Affecting A-30 altitude encoders to serial number 23849

November 11, 1989

Modification of the A-30 to MOD 2 status

FIGURE 1

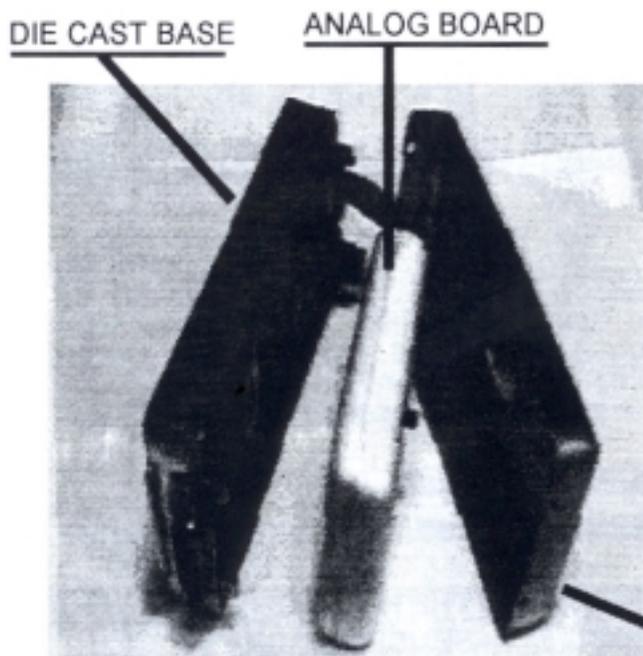
1. Remove the A-30 top cover by removing the four retaining screws which affix it to the die cast aluminum base. (see figure 1)
2. Remove the analog board assembly by disconnecting the 10 pin plug located at the end of the ribbon cable from the main board assembly.

FIGURE 2

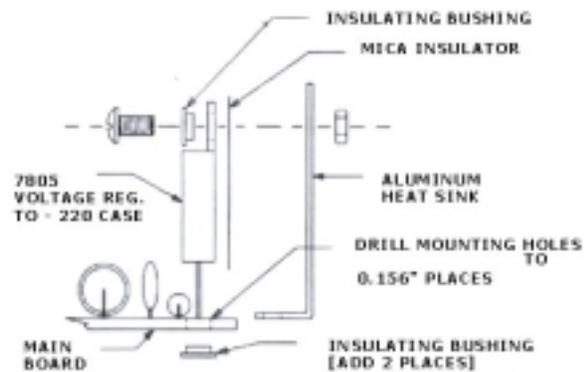
4. Remove the screw which attaches the voltage regulator heat sink to the voltage regulator. (see figure 2)
5. Using a 5/32" drill enlarge the two main board attaching screw holes pi (see figure 2) making sure that the drill removes all of the conductive trace material between the upper and lower layer of the board. If any conductive material remains in the hole remove any remainder with a bearing scraper or exacto knife.

6. Reassemble the unit installing the insulator bushings and mica insulator as shown in figure 2. A non conductive grease or adhesive may be used to hold the insulator bushings in place during assembly.
